1394B “LEGACY CONNECTOR” SECTION  
PROPOSAL FOR MODIFICATIONS TO WORDING IN SECTION 4.2.1.1,  
AND FIGURE 4-7  
(Ref. IEEE 1394-1995 AS BASIS)  
BILL NORTHEY, JUNE 7, 1999

Proposed changes are highlighted

#### Figure 4-6 Connector Insertion Wafer

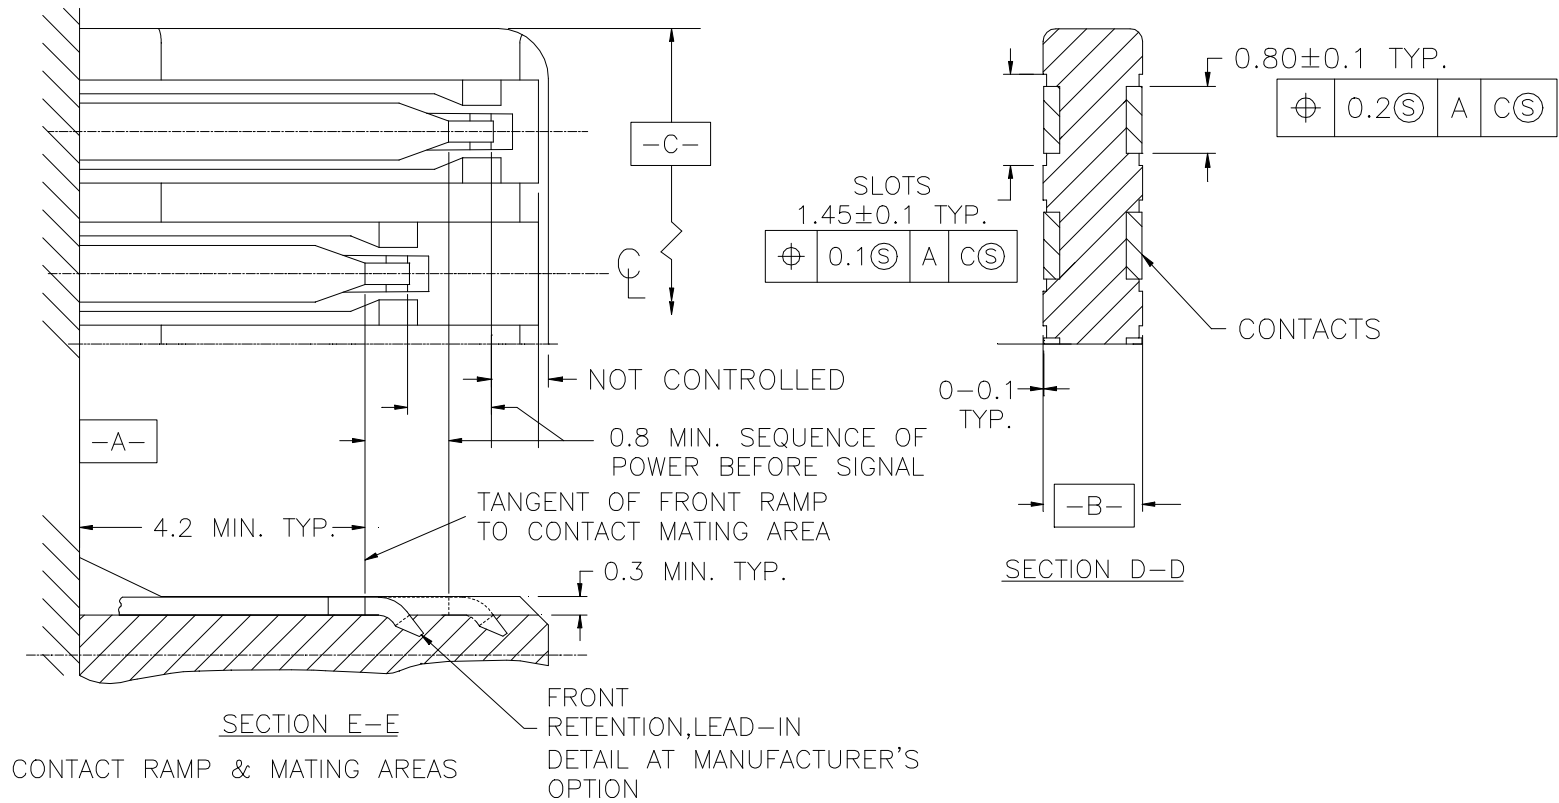
Both the Hertzian and Non-Hertzian variations shown in Section D-D and Section E-E provide alternative and acceptable constructions of “plug compatible” designs. Regardless of the contact variation, the connectors must adhere to the performance criteria defined in 4.2.1.3.

Add to Notes: 3 – Hertzian contact profile shown for reference only.
